APPLICATION NO.	FILING DATE	FIRST NAMED INVENTOR	ATTORNEY DOCKET NO.	CONFIRMATION NO.
10/634,235	08/05/2003	Peter Bernhardt	1-24671	6403

Office Action Summary

DETAILED ACTION

Epp et al., 5,882,137

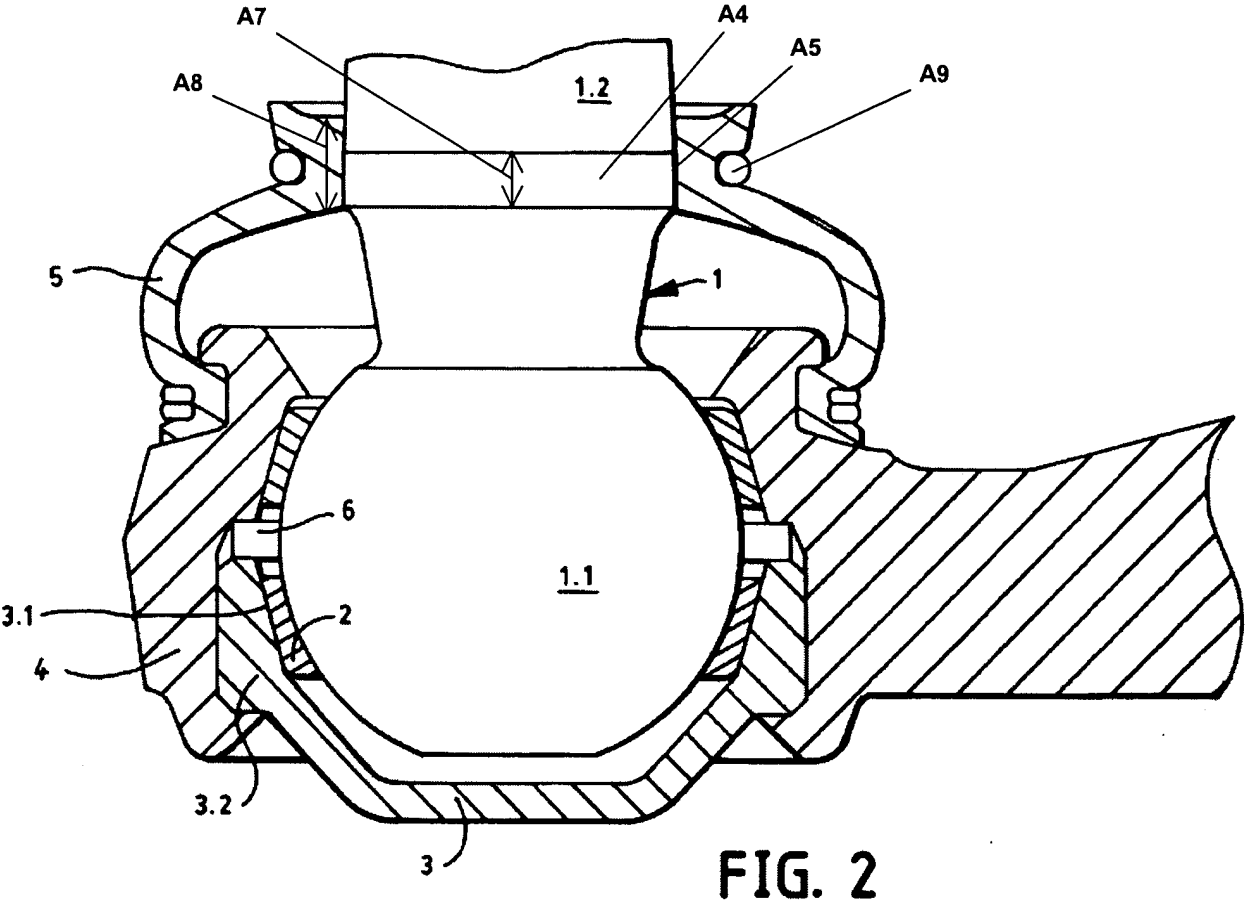
Claims 6 and 8 are rejected under 35 U.S.C. 102(b) as being anticipated by Epp et al., 5,882,137 (see marked-up attachment).

Regarding claim 6, Epp et al. disclose, in Figure 2, a ball joint including a housing **4**, a ball stud **1**, and a sealing bellows **5**. The sealing bellows **5** lies against the housing **4** and the ball stud **1**. The ball stud **1** has a holding surface **A5** against which a sealing surface **A6** of the sealing bellows **5** lies. The sealing surface **A6** defines a first axial dimension **A7**. The holding surface **A5** defines a second axial dimension **A8**. The first axial dimension **A7** is greater than the second axial dimension **A8**.

Regarding claim 8, the sealing bellows **5** is provided with a metal ring **A9** urging the sealing surface **A6** against the holding surface **A5**.

Regarding claim 12, Epp et al. disclose, in Figure 2, a ball joint including a housing **4**, a ball stud **1**, and a sealing bellows **5**. The sealing bellows **5** lies against the housing **4** and the ball stud **1**. The ball stud **1** has a holding surface **A5** against which a sealing surface **A6** of the sealing bellows **5** lies. The sealing bellows **5** is provided with

a metal ring **A9** urging the sealing surface **A6** against the holding surface **A5**. The sealing surface **A6** defines a first axial dimension **A7**. The holding surface **A5** defines a second axial dimension **A8**. The first axial dimension **A7** is greater than the second axial dimension **A8**. However, Epp et al. fail to disclose the holding surface **A4** and the sealing surface **A5** being cylindrical. Applicant should note that the courts have consistently held that a change in the shape of a prior art device is a design consideration within the skill of the art. In re Dailey, 357 F.2d 669, 149 USPQ 47 (CCPA 1966). Further, since there is no criticality for making the holding surface and the sealing surface cylindrical, it would have been obvious to choose any mating surface configuration. In any case, the German patent, in Figure 2, or Dorr et al., in Figure 1, provides evidence that a holding surface and the sealing surface are known to be cylindrical. Accordingly, it would have been obvious to make the holding surface and the sealing surface in Epp et al. cylindrical instead of conical as both configuration have been equally known to provide a sealing interface.

Fig. 2

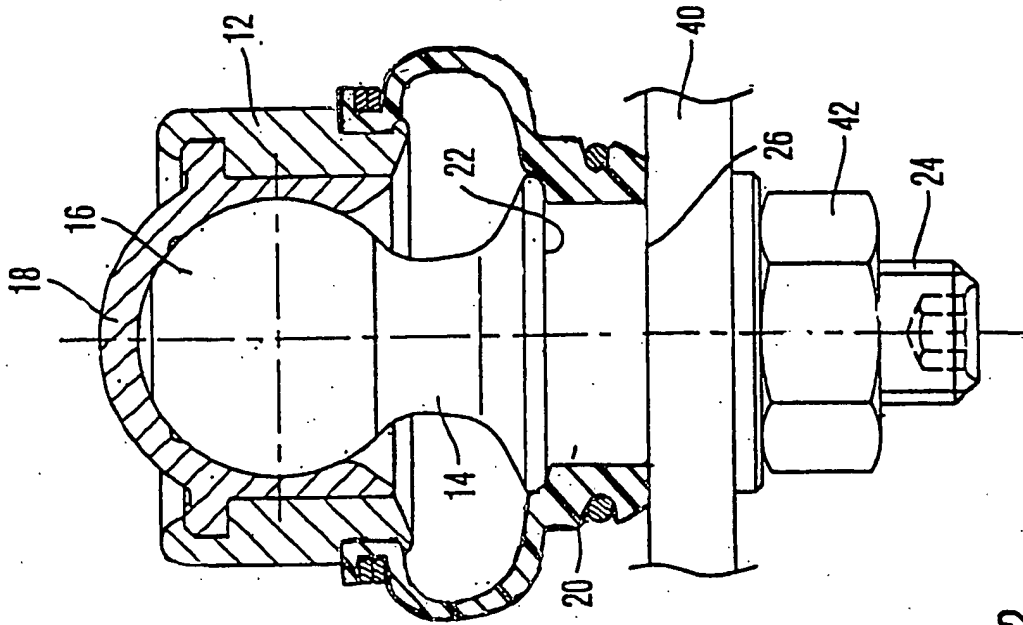
The drawings are objected to because the lead lines of reference characters 22 (Fig. 1), 30, and 20 (Fig. 2) does not completely extend to the location the references characters represent. See scanned drawings in the PAIR system.

Corrected drawing sheets in compliance with 37 CFR 1.121(d) are required in reply to the Office action to avoid abandonment of the application. Any amended replacement drawing sheet should include all of the figures appearing on the immediate prior version of the sheet, even if only one figure is being amended. The figure or figure number of an amended drawing should not be labeled as "amended". If a drawing figure is to be canceled, the appropriate figure must be removed from the replacement sheet, and where necessary, the remaining figures must be renumbered and appropriate changes made to the brief description of the several views of the drawings for consistency. Additional replacement sheets may be necessary to show the renumbering of the remaining figures. The replacement sheet(s) should be labeled "Replacement Sheet" in the page header (as per 37 CFR 1.84(c)) so as not to obstruct any portion of the drawing figures. If the examiner does not accept the changes, the applicant will be notified and informed of any required corrective action in the next Office action. The objection to the drawings will not be held in abeyance.

Fig. 1

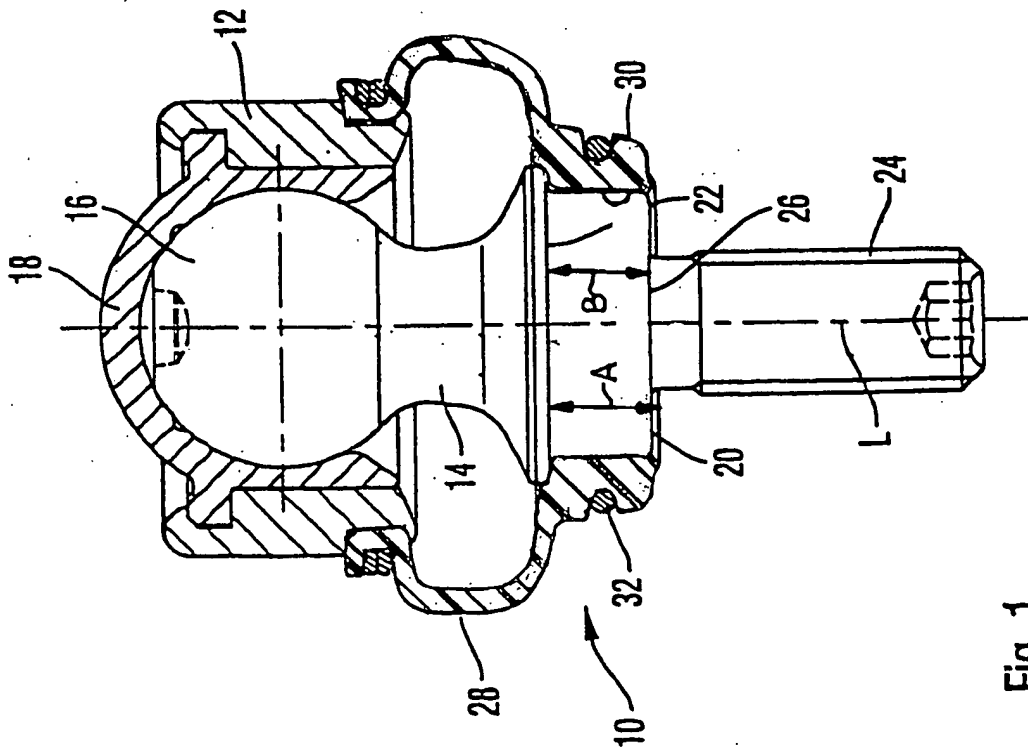
The drawings are objected to as failing to comply with 37 CFR 1.84(p)(4) because reference characters "20" and "26" have both been used to designate the

same contact surface in Figure 1. Reference character "20" should be shown as in Figure 2.
